Refined fairness

This contribution provides replacement text for Clause 9 of P802.17 RPR D2.6. Several types of changes are proposed:

20
 21 **Figure 9.12—Aggressive tracking of *localFairRate* computations**

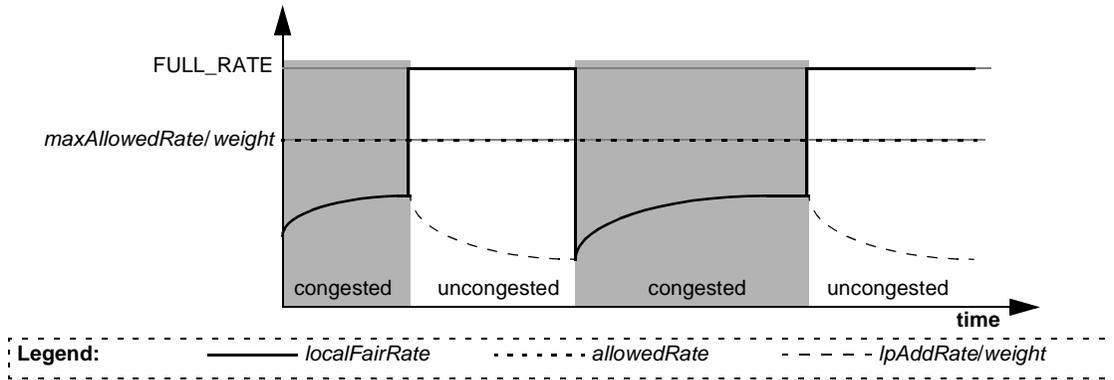
2
 3 The computation of *localFairRate* value is based on congestion conditions, as illustrated Figure 9.12. When
 4 uncongested, the *localFairRate* value is set to FULL_RATE and *allowedRate* approaches an
 5 *lpAddRate/weight* traffic limit. When congested, *localFairRate* and *allowedRate* are immediately set to
 6 the *lpAddRate/weight*.

41
 42 **Figure 9.13—Tracking of *localFairRate* computations**

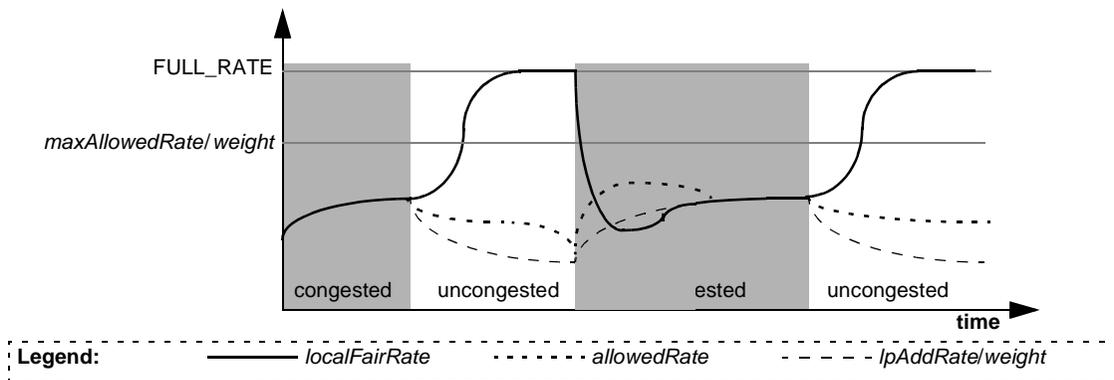
24
 25 The computation of *localFairRate* value is based on *lpAddRate/weight* congestion-condition estimates,
 26 computed as illustrated Figure 9.13. When congested, the *localFairRate* value approaches an
 27 *lpAddRate/weight* traffic rate; when uncongested, *localFairRate* approaches the FULL_RATE value.

43
 44 The *allowedRate* tracks the *localFairRate* during congested intervals, while remaining constrained to a
 45 *maxAllowedRate/weight* value during uncongested intervals.

Figure 9.14—Fairness domain boundaries

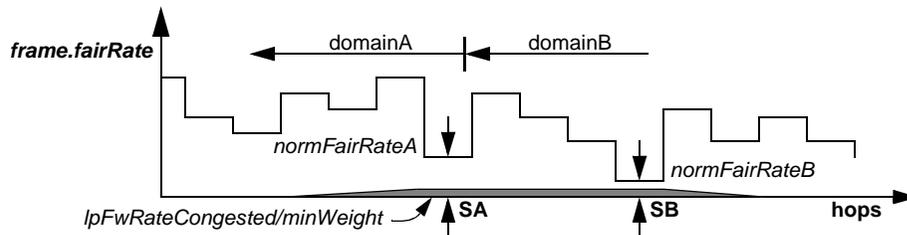
A congestion domain ends when an upstream station A senses no need to inhibit contention-point traffic at downstream station B, as illustrated Figure 9.14.

Station SA is aware of downstream congestion point at station SB, based on its reception of the $normFairRateB=fairFrame.fairRate$ value. Station SA is also aware of $lpFwRateCongested/minWeight$, a conservative estimate of the upstream transmission rates.

If the upstream transmission rates are less than their restricted-by- $normFairRateB$ values, station SA assumes these stations flows would also be unaffected by a larger $normFairRateA$ value. Thus, station SA can communicate a $fairFrame.fairRate=normFairRateA$ to its upstream neighbors, without impacting traffic through the more congested downstream station SB.
